J7230A-02-S

S E R V I C E N O T E

J7230A OmniBER OTN

Defective handle may cause personal injury

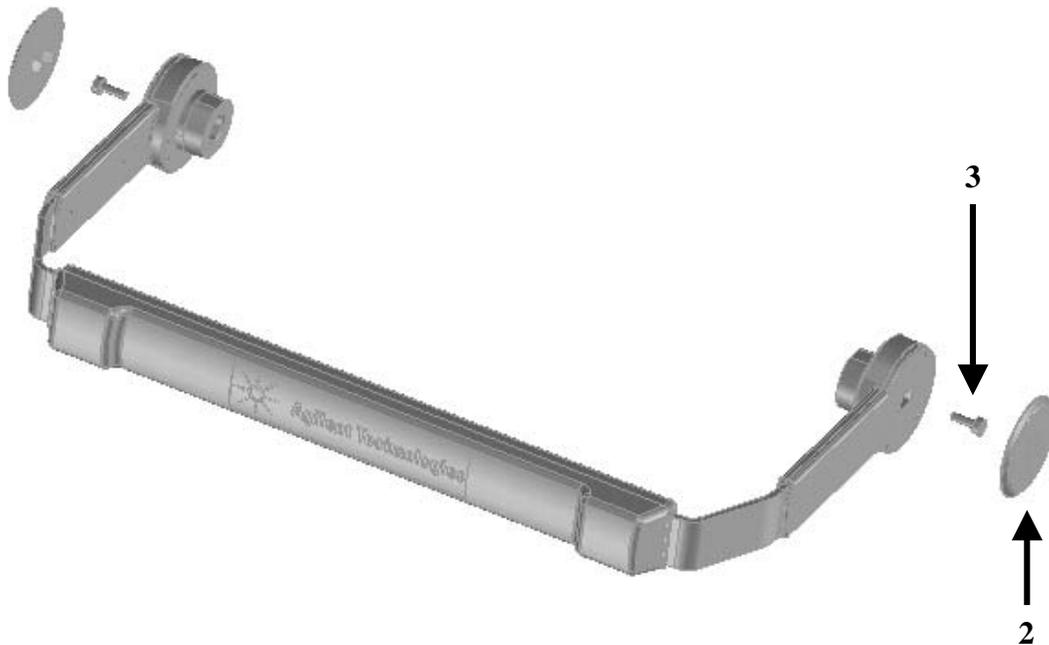
The handle of the J7230A OmniBER OTN may become loose over time. It is highly unlikely that the handle will become completely separated from the J7230A instrument. However, if the handle does become loose, there is a risk that it may slip suddenly. It is possible that anyone carrying the instrument by the handle could sustain injury while trying to compensate for the slippage of the handle.

If the J7230A corresponds to one of the serial numbers listed overleaf, a new handle will be fitted by Agilent-Qualified personnel. This will be carried out free of charge, and at the customers' convenience.

1. Put the handle in the horizontal position.
2. Remove the plastic End Caps
3. Remove the single central screw accessible through handle aperture on each side using a Torx T-15 driver. **Please note that the screws cannot be fully extracted from the handle assembly.**
4. When both screws are fully loosened, pull the handle away from the Front Casting at each side in turn.

1. With the J7230A instrument flat on a bench, position the handle assembly such that, when fitted in the horizontal position, the Agilent Technologies logo on the handle assembly is the correct way up as viewed from the front.

2. Adjust the assembly on the inside of each end of the handle such that the small pins on the handle align with the holes on the J7230A frame. To do this, push the socket gear on the inside of each end of the handle against the spring, and turn.

3. Pull the ends of the handle apart slightly and fit the handle onto the J7230A instrument, ensuring that the small pins lock into the holes on the instrument.

4. Tighten the hex screw on one side of the handle to the correct torque (2.2Nm) using a flat bladed screwdriver.
5. Remove the screwdriver from the handle assembly. Examine the alignment of the hex screw relative to the tab washer.

6. If necessary, tighten the hex screw further until one of its' faces is aligned with the vertically bent tab on the tab washer.
7. Insert a flat bladed screwdriver into the handle assembly. Bend one of the tabs on the tab washer against the flat of the hex screw, then over, locking the screw in place.

8. Repeat steps 4 to 7 on the other side of the handle.
9. Fit handle caps with Agilent logo onto both sides of the handle.
10. Log the serial number of the J7230A instrument modified, along with any other comments you may have. Feedback this information to **TNTD_Support@agilent.com**.
